LOCAL MEMBER OBJECTION

APPLICATION No. **19/03052/MJR** APPLICATION DATE: 21/11/2019

LOCATION: SITE OF FORMER MARLAND HOUSE AND NCP CAR PARK,
CENTRAL SQUARE, CITY CENTRE, CARDIFF, CF10 1PF

PROPOSAL: EXTENSION OF OFFICE DEVELOPMENT WITHIN THE
CARDIFF INTEGRATED TRANSPORT HUB (ITH), REMOVAL
OF A RETAIL UNIT TO CREATE AN ENLARGED OFFICE
RECEPTION AND ALTERATIONS TO PUBLIC REALM

Title
Proposed Site Plan

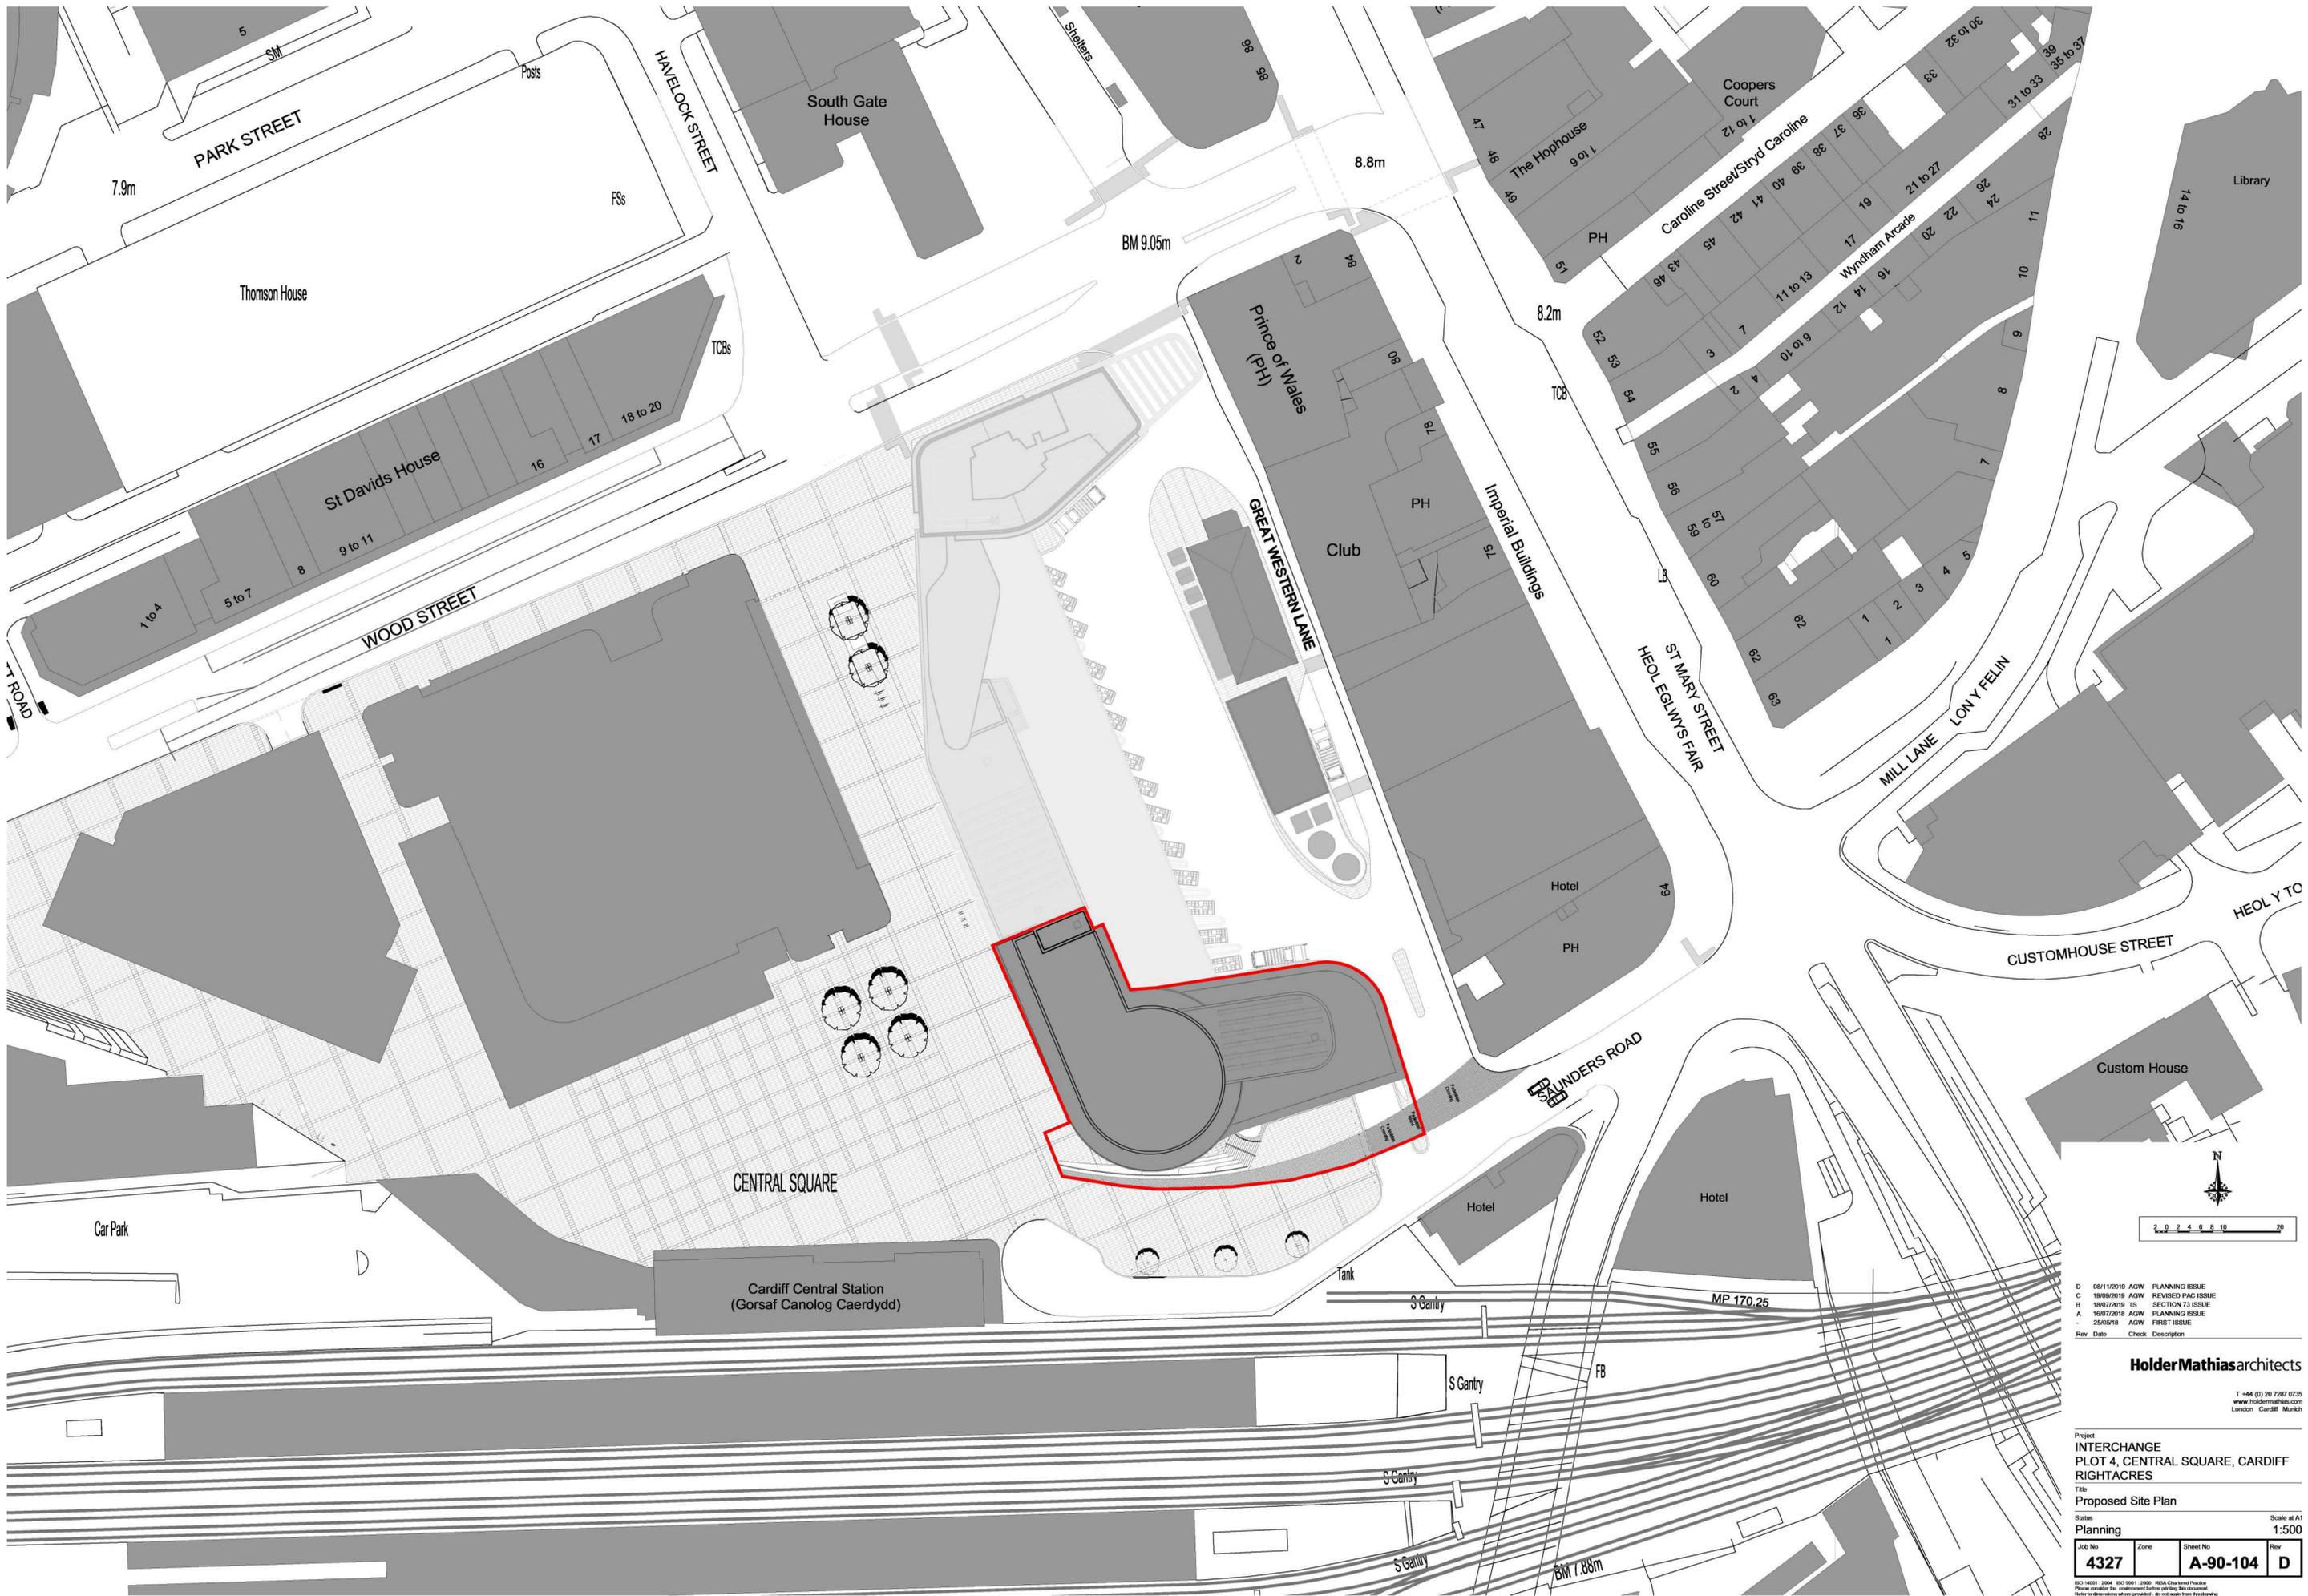
- 8.5 *Public Realm works:* The extent of the public realm is defined on the Proposed Site Plan A-90-104 revD. It includes part of Marland Street, the covered 'amphitheatre' area alongside the bus station entrance, the public realm adjacent to the office entrance, and the pedestrian crossing works in front of the car park entrance.

- 8.6 The specification and overall appearance will be as the Central Square public realm (Planning permission 14/02405/MJR for the BBCHQ and associated public realm).The surfacing material will be predominantly granite paving to match improvements to The Hayes and St. Mary's Street and in line with the objectives of the Cardiff City Centre Public Realm Manual. Details of the hard landscaping materials palette, the pedestrian crossing works, tree planting, street furniture and lighting are subject to condition.

- 8.7 The on-site public realm proposals are acceptable subject to a public realm works condition, and integration with emerging proposals for the wider area.

5. *Public realm Works:*
 Within six months of the grant of planning permission full details of the public realm works within the red line, adjacent to the interchange building, as shown in principle on the Proposed Site Plan A-90-104 rev D, shall be submitted for approval by the Local Planning Authority. The details to include timing and implementation, surfacing, kerbs, edging, drainage, lighting, lining, signing, telematics/ signals/ CCTV and communications, street furniture, cycle stands, soft and hard landscaping, and tactile guidance path/paving. The agreed scheme to be implemented in accordance with the approved details prior to beneficial occupation of the interchange building. Reason: To facilitate safe and convenient access to and egress from the proposed development, and in the interests of highway and pedestrian safety.
